DESIGN ADVISORY BOARD Tuesday, October 28, 2014 Conference Room 12, City Hall, Burlington, VT AGENDA

15-0468CA: 166 EAST AVENUE (RL, Ward 1) Germain Mopa

MEMORANDUM

To: The Design Advisory Board
From: Mary O'Neil, AICP, Senior Planner *M O'Neil*
RE: ZP 15-0468CA; 166 East Avenue
Date: October 28, 2014

RIGHT SIDE VIEW - SOUTH
SCALE: 1/8"=1'-0" (1:96)

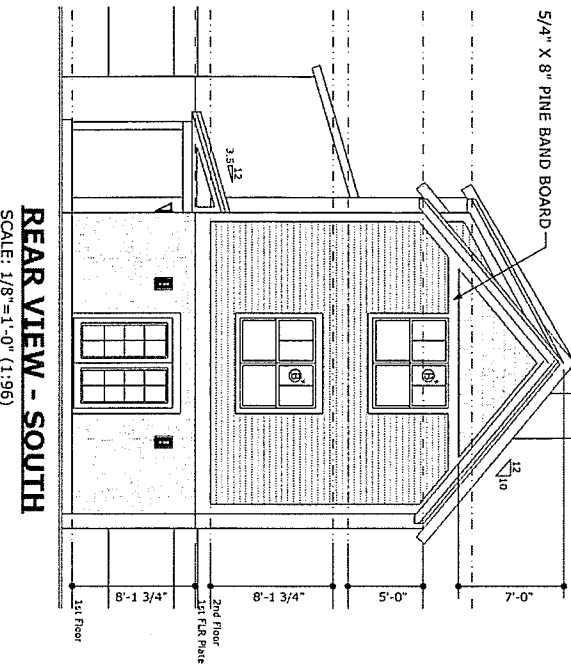
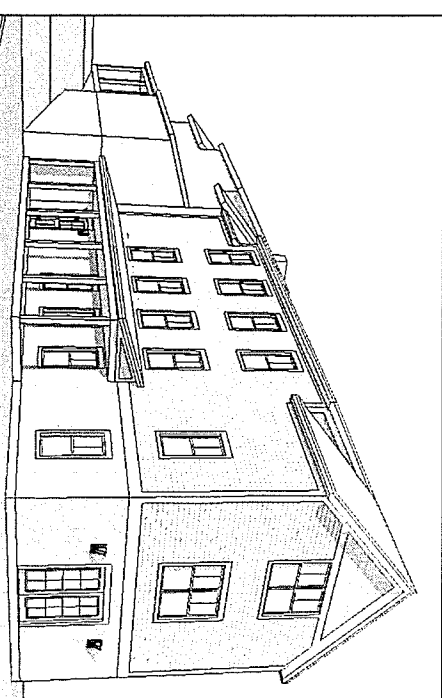
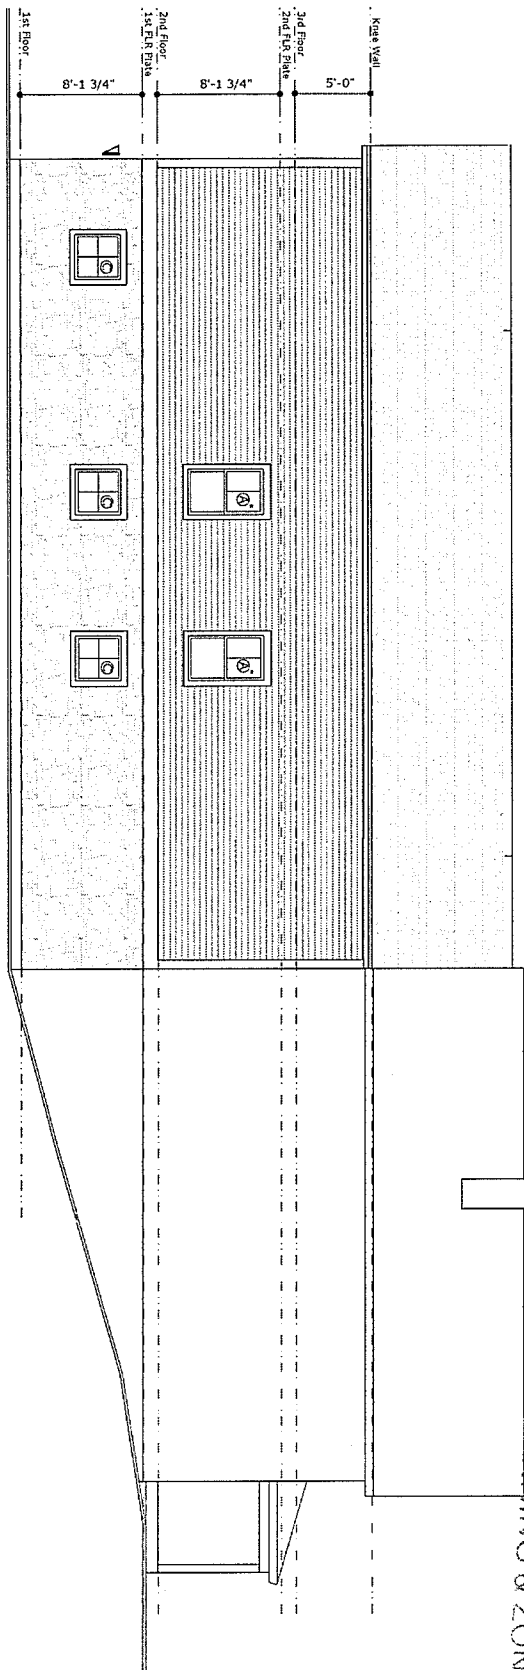
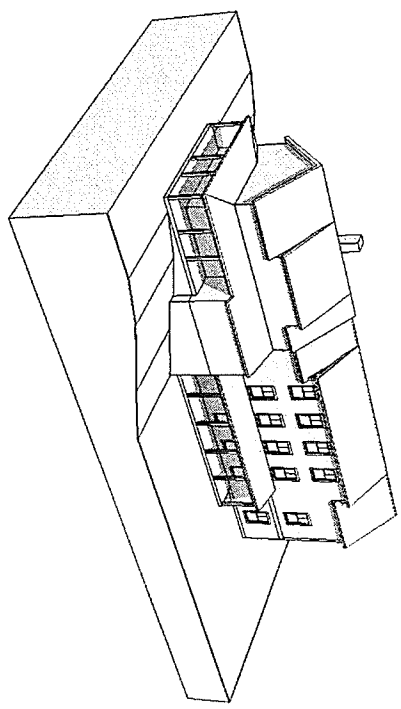
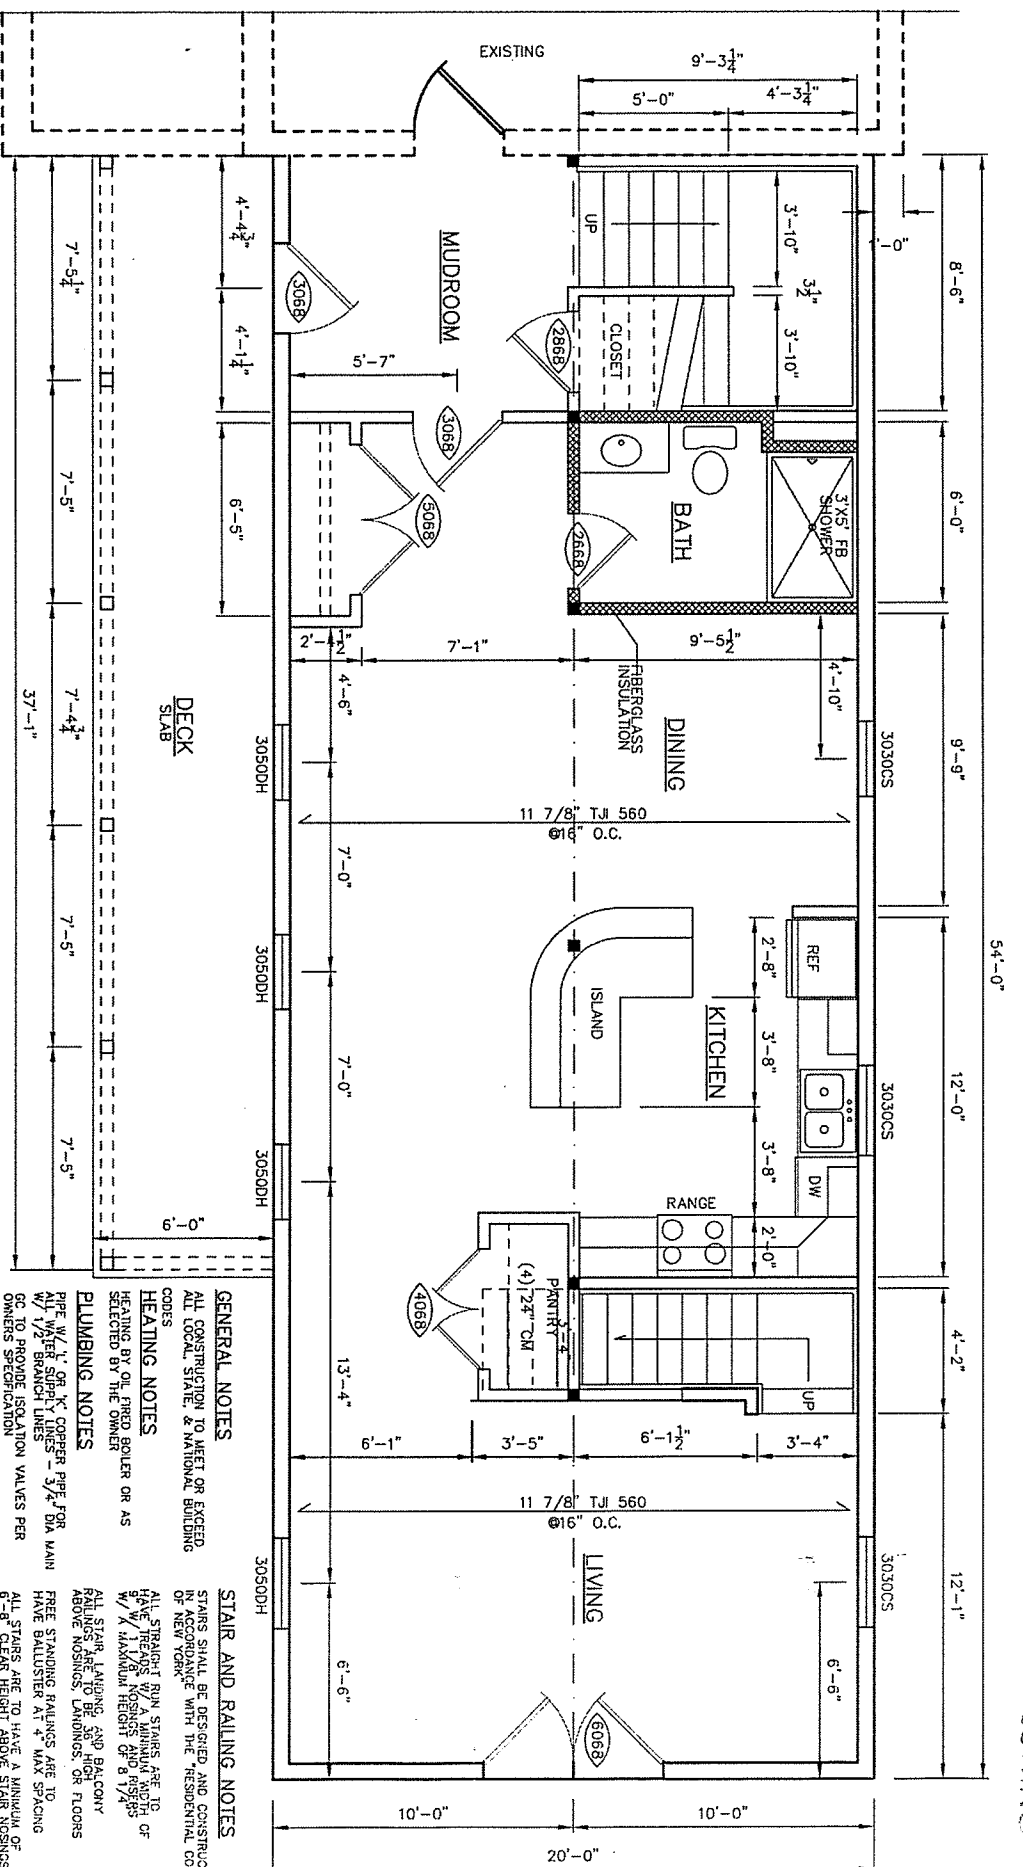
As illustrated in the modeling study, the building height may be technically inches less than the original house, but the large exposure coupled with the raised dormer roof visually increases the apparent height; in conflict with this standard.

A gabled roof is proposed, with a full height dormer on the south elevation. Both of these features are present on the existing house (although in much smaller scale.)

Window pattern on the southern elevation are rhythmic in their placement, and centered under the full dormer. Paired double hung sash are illustrated in the east elevation; the north elevation has only a handful of windows on the first and 2nd floor; none on the third. Presumably this is to provide privacy from the immediate neighbors.

Plans define materials thus: "Siding, trim, gable and eave details to match existing." The Assessor's files define existing materials as wood clapboard with an asphalt shingle roof. The applicant will need to confirm proposed materials.

2. This board recommends approval subject to a change in the roofline to minimize or eliminate the continued plane of eaves. The effort is to visually lower the rear roofline. A revised plan which is determined by staff to meet this guidance may be forwarded to the DRB with a recommendation for approval.

3. All plans forwarded to the DRB must include specifications for siding, trim, walkway and driveway materials.
4. The DAB requests removal of language in the staff report that suggests the likelihood of a violation based on greater intensity of use than allowed by the CDO.

SITE PLAN
166 EAST AVENUE
3740 SF: PROPOSED COVERAGE
10890 SF: LOT
34.34% : LOT COVERAGE

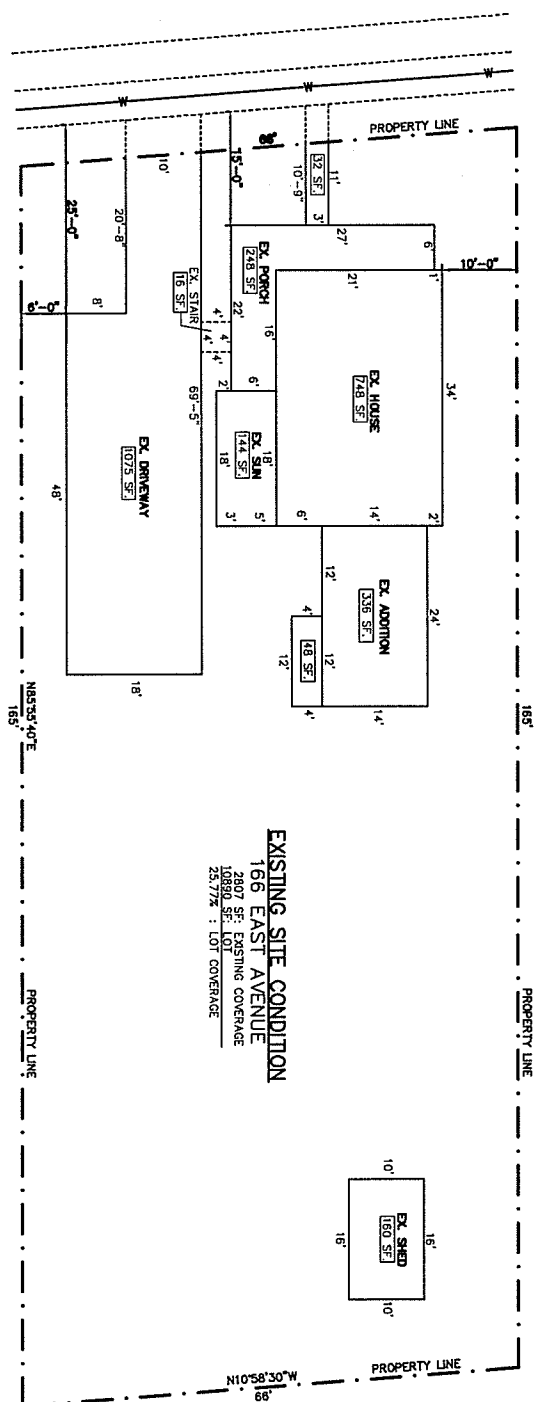
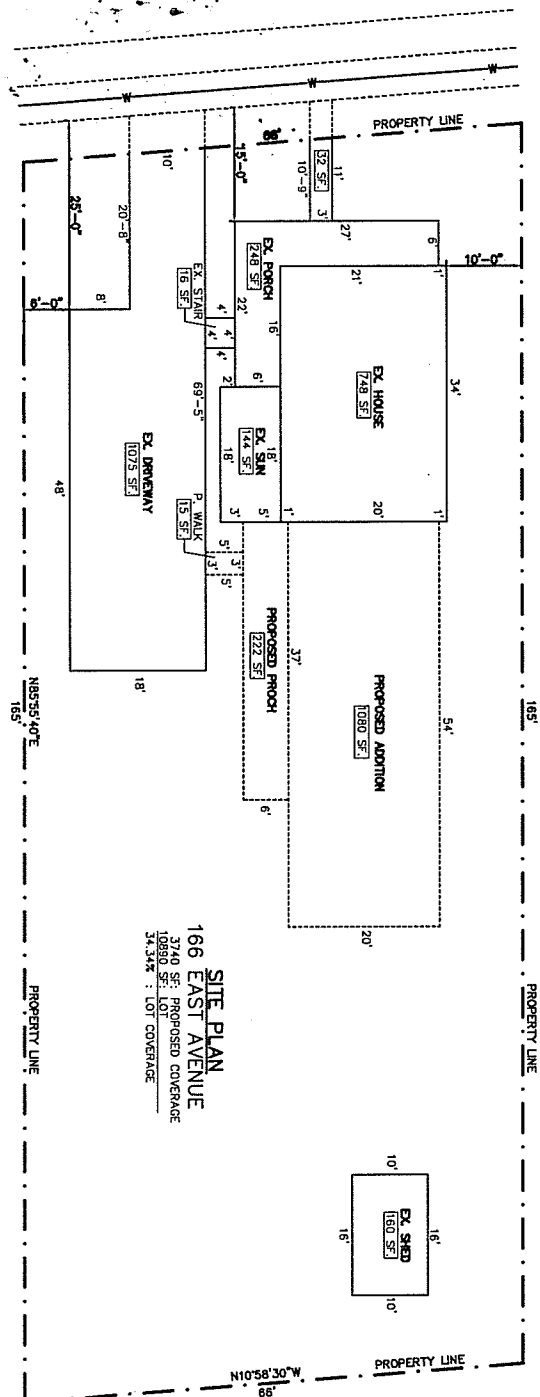
The submitted site plan for existing conditions does not match aerial and historic ortho views of the parking pattern on the property. Since 1978, it is clear that the parking has moved away from a circulation pattern to the rear garage, toward a curved pattern that appears to cross property lines to the south.

The “existing” parking plan is not factual on the submission, and the expanded parking area has not been permitted. The submission materials will have to be amended to reflect actual conditions and the applicant is challenged to provide permits that demonstrate approval for the parking area. Absent permits, the site will need to be returned to its configuration prior to 1999.

As a duplex, only 4 parking spaces are required. The large parking area illustrated is excessive for the use, and it does not appear to have been permitted via the zoning process. It certainly seems to extend beyond the property boundaries.

As noted, small walkways between the parking area and the structure are illustrated on the proposed site plan.

The proposed parking area appears to accommodate a significant number of vehicles, which may require appropriate shading per this standard. The applicant will be required to show individual parking spaces, meeting appropriate back-up length and required landscaping on the site plan.

1. Revise plans to include:
 - a. Walkway from 2nd (rear) unit to city sidewalk; distinct and differentiated from the driveway. Separation may be materially, vertically or horizontally. (Use different pavement materials, separate by grass, fence or landscaping.)

- b. Parking plan shall define 4 separate parking spaces.
 - c. Curbing or other form of parking barrier shall be included.
 - d. Identify bicycle parking for 2 bikes. Suggested within existing basement.
